DART SERVICE INSTRUCTION

TO AMEND INSTALLATION INSTRUCTIONS IIN-D117-837 REV. B AND
INSTRUCTIONS FOR CONTINUED AIRWORTHINESS ICA-D117-837 REV. 1

REF. TCCA STC: SH13-22

FIGURE 1. D4911-5 BRACKET INSTALLATION
(RH INSTALLATION SHOWN, LH OPPOSITE)

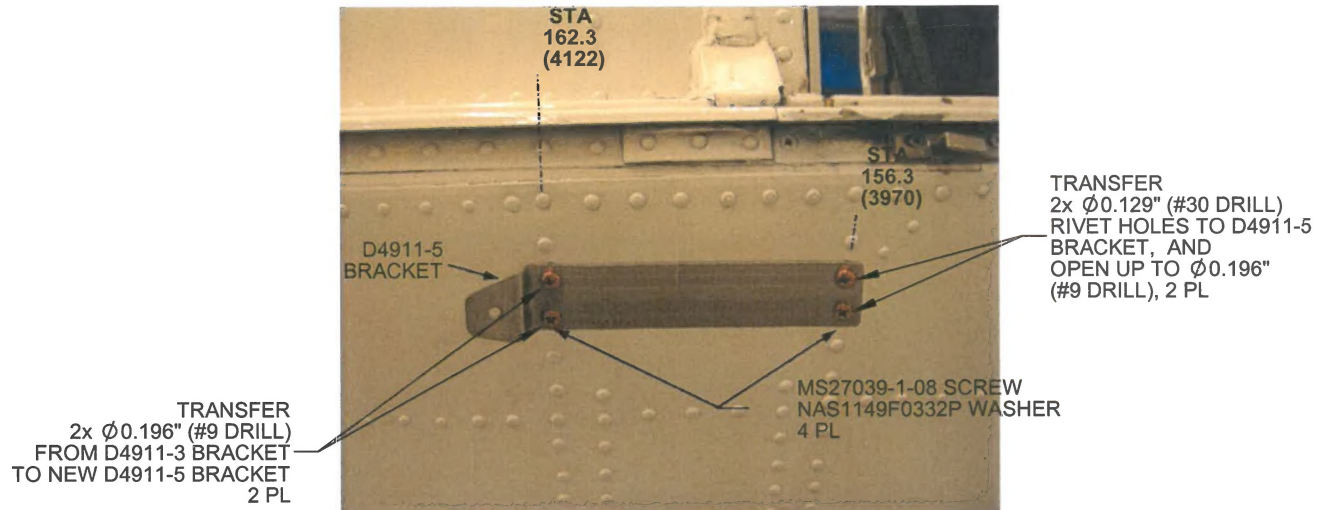
The purpose of this Dart Service Instruction (DSI) is to provide instructions to replace the D4911-3 Bracket with a D4911-5 Bracket for customers who already have D117-837-011 at CHG 002 or CHG 003. The D4911-5 Bracket will better distribute the drag load from the D117-837-011 Heli-Utility-Basket to the airframe in flight.

- 3.1 Temporarily remove LH/RH side cabin outboard floor panels as applicable.
- 3.2 Using D4911-3 Bracket as a template, transfer 2x $\varnothing 0.196$ " (#9 drill) holes from D4911-3 to new D4911-5 Bracket as shown in Figure 1.

- 3.3 Using the D4911-5 as a template, remove two rivets at STA 156.3 (3970) under the D4911-5 Bracket. Transfer drill these rivet holes to the D4911-5 Bracket as shown in Figure 1. Enlarge rivet holes to $\varnothing 0.196$ " (#9 drill) in the aircraft rib and on the D4911-5 Bracket. Transfer $\varnothing 0.098$ " (#40 drill) for MS21069L3 anchor nut and c/sink/dimple holes for NAS1097AD3-(4) rivet as shown in Figure 2. Deburr and touch-up aircraft holes with Alodine 1200/1201 per MIL-C-5541.

- 3.4 Install 2x MS21069L3 anchor nuts using NAS1097AD3-(4) rivets as shown in Figure 2.
- 3.5 Install D4911-5 Bracket into the aircraft ribs using 4x MS27039-1-08 screws and 4x NAS1149F0332P washers as shown in Figure 1. Torque screws to 20-25 in-lbs (2.3-2.8 N-m).
